Docket Item # 1 BAR CASE # 2010-0241

BAR Meeting September 22, 2010

**ISSUE:** Alterations

**LOCATION:** 527 North Patrick Street

Figure 6. Existing and proposed plans.

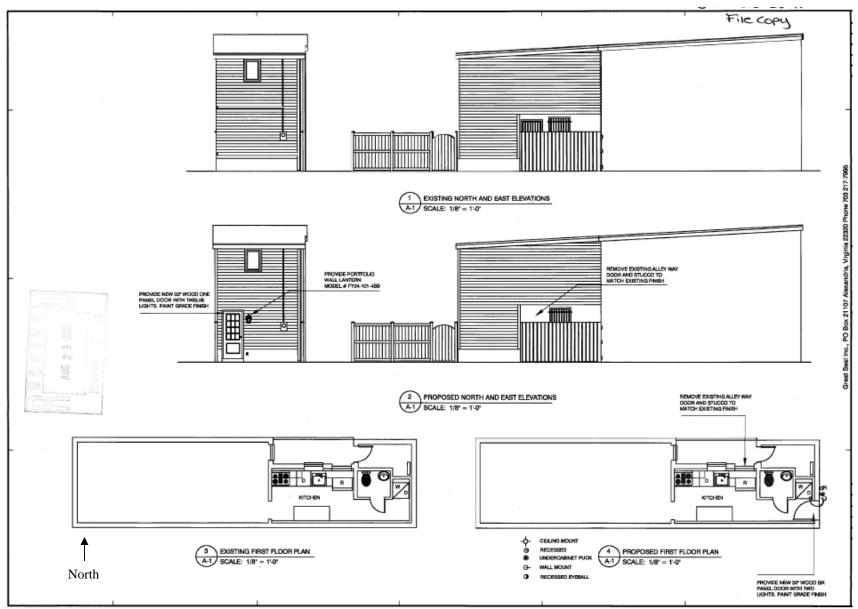
The applicant is requesting approval of a Certificate of Appropriateness for alterations on the side and rear elevations at 527 North Patrick Street. On the side (north) elevation, the applicant has proposed to remove an existing alley door in a recess along the alley. The applicant proposes to fill in the door opening with stucco, painted to match the exterior. The applicant also proposes to install a new multi-light wood door and simple bronze lantern style light fixture on the rear (east) elevation. The proposed work is located behind a wood fence and minimally visible.

The proposed alterations are minimal in scope and consistent with the *Design Guidelines*. The *Guidelines* note that alterations should not result in the loss of historic material and warn that the cumulative effect of inappropriate changes can erode the character of the district. Filling in a window and adding a door on secondary elevations are generally considered modest alterations and represent typical changes to a building over time. In addition, it is clear from the plans submitted, and from a site visit, that the existing floor plan configuration is not practical as there is currently no access to the rear yard. Further, historic map research has indicated that the rear portion of the building where the door is proposed to be installed is a much later addition. The new door and the lantern style porch light will be minimally visible due to the presence of a six foot wood fence in the rear yard. The proposed door and lantern are appropriate for a rear elevation. From a recent site visit, Staff observed that the window opening on the side elevation has already been filled in with stucco. Staff spoke with the applicant who understands that no further work is to occur.

**STAFF RECOMMENDATION**: Staff recommends approval of the application as submitted.
